CITY OF OREGON CITY HISTORIC REVIEW BOARD (HRB) AGENDA

2. Recommendation of Adoption of the Design Guidelines for New Construction- Middle Housing to the City Commission
3. New Construction of a Tri-Plex on Land that is Part of a Designated Landmark - Rasmussen-Buol House (151 Molalla Avenue) (GLUA-23-00001; HR 23-00002)

**PRESERVATION GRANT REQUEST
HISTORIC REVIEW BOARD
March 20, 2023**

REVIEWER: Christina Robertson-Gardiner, AICP Senior Planner

1/4" = 1'-0"

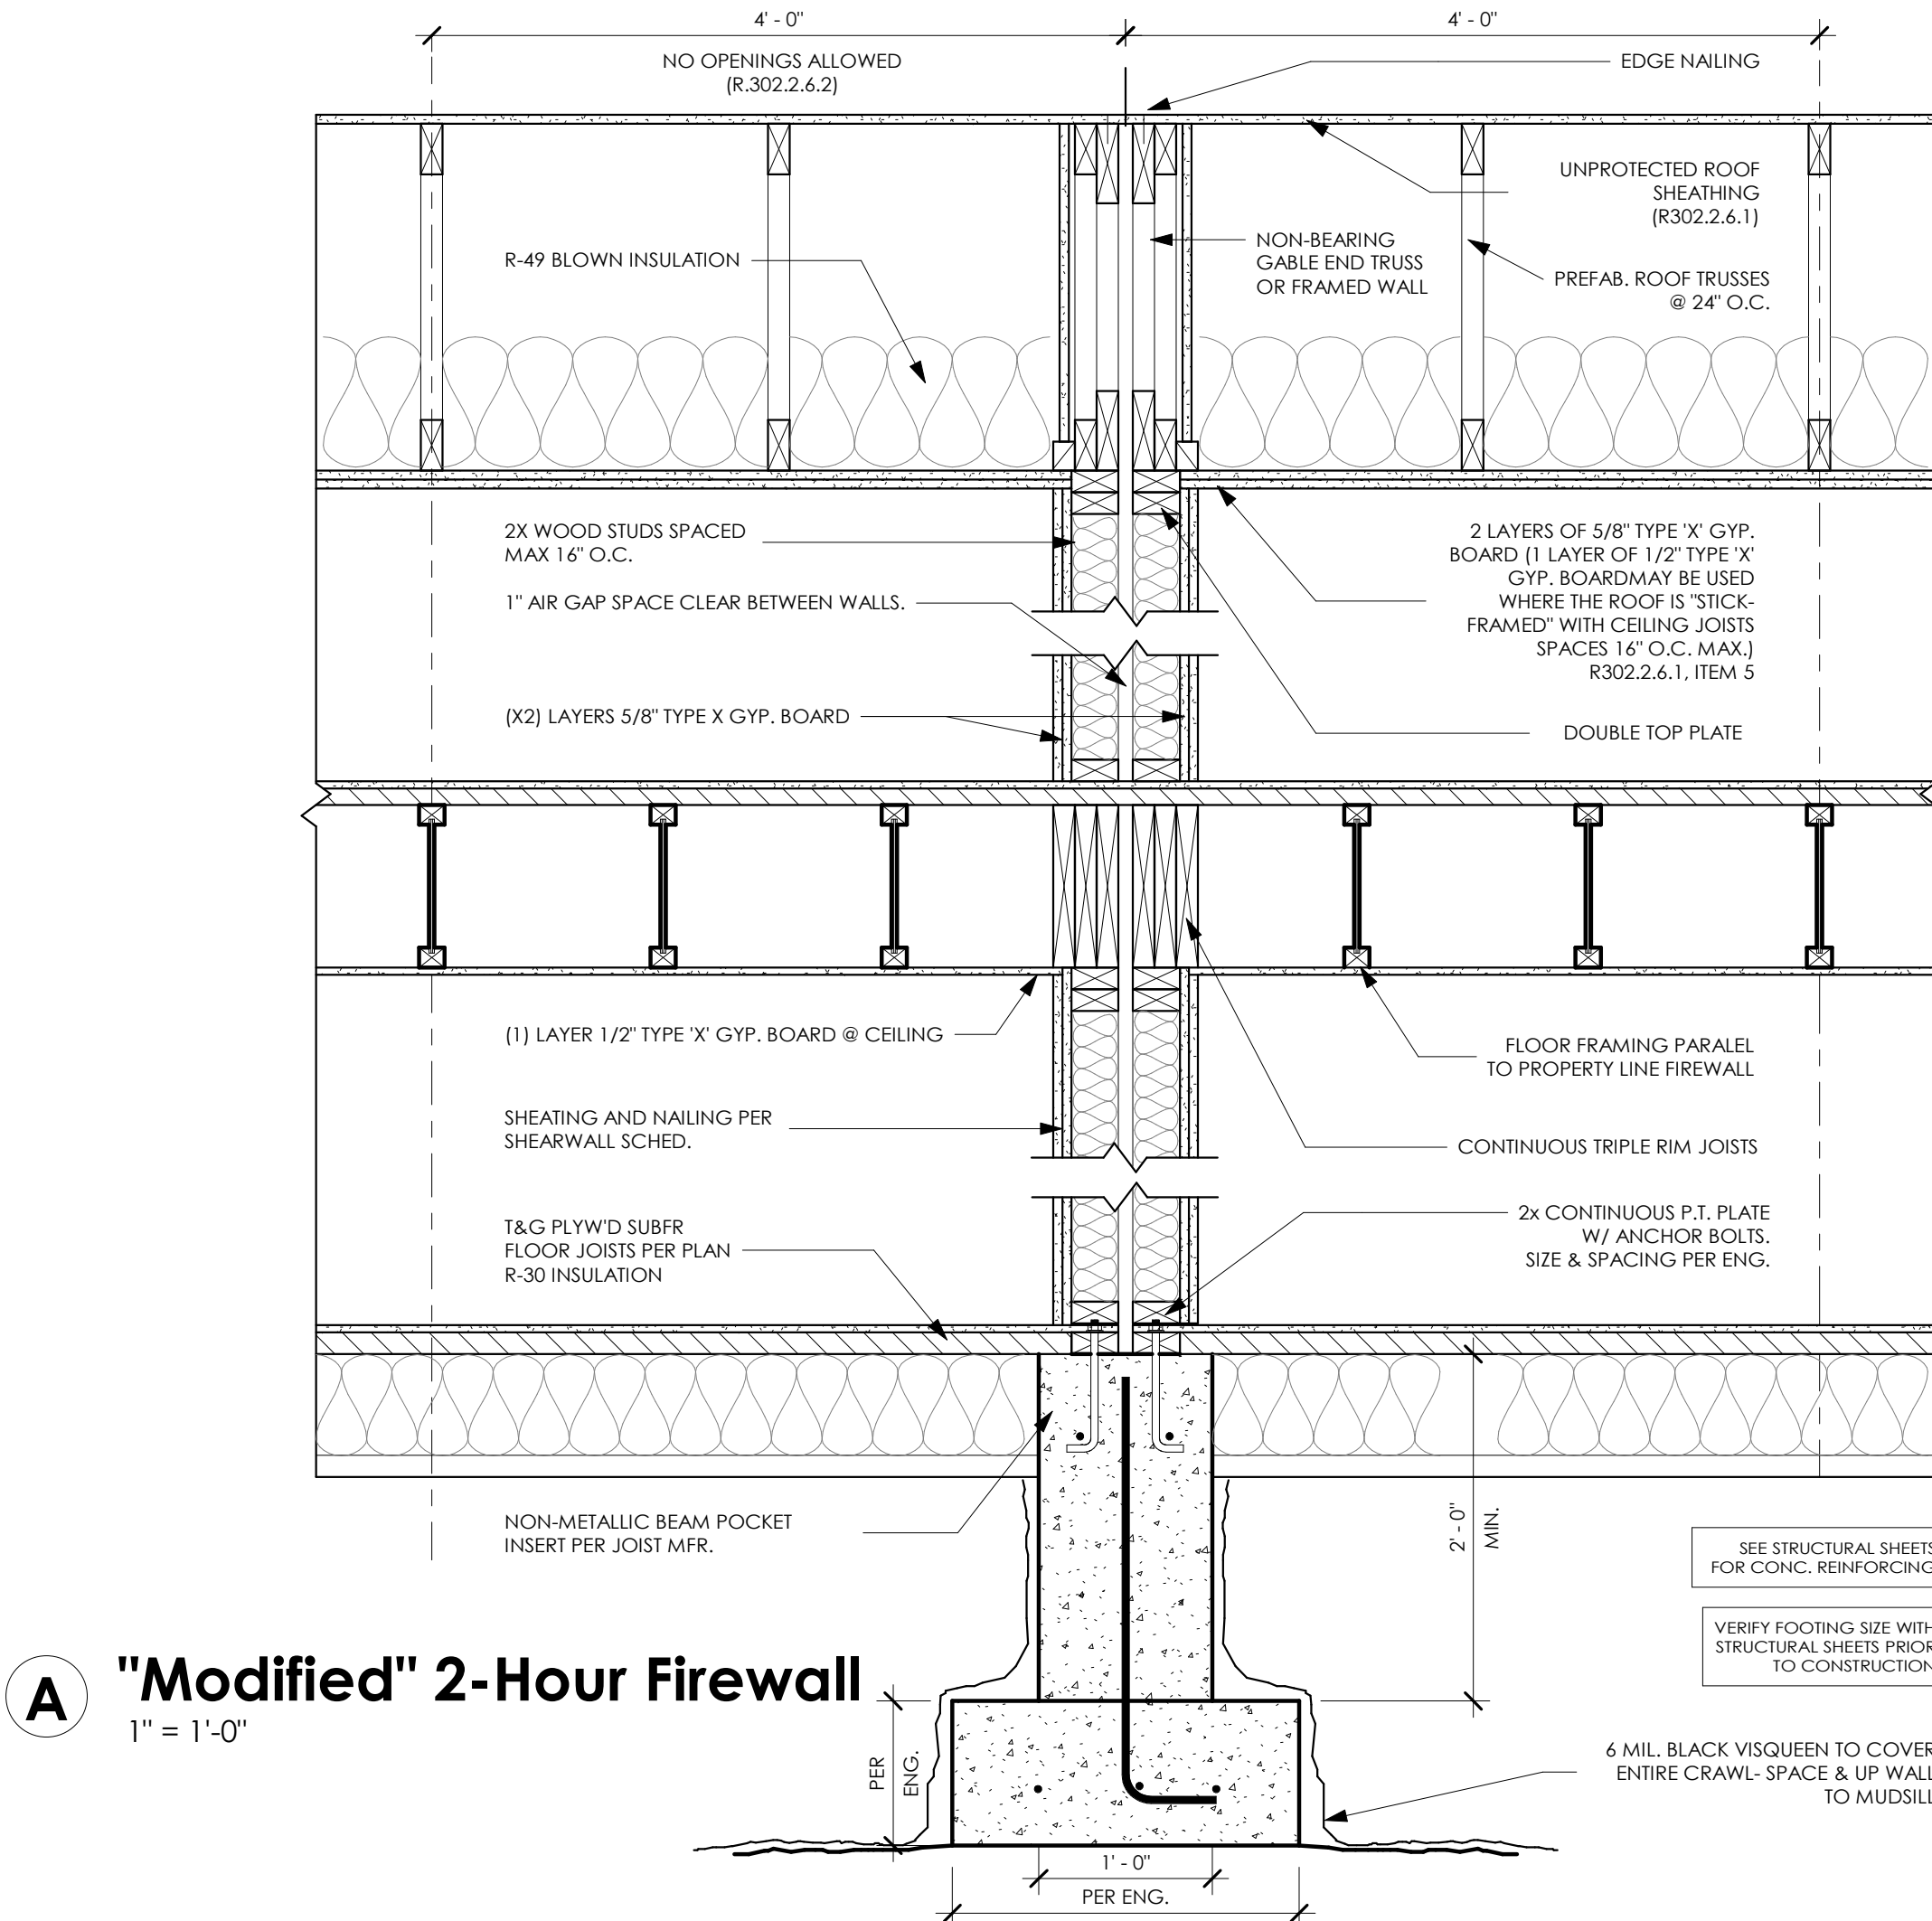
Please note that the stair design from the specification (Sheet A6) below does not match the 3rd rendering showing horizontal railings.

- d. The porch design shall align with the specification found in sheet A6.
 - e. Corner trim shall be utilized on the building.
 - f. Porch railing, decking, and posts shall be painted to match the color scheme of the house.
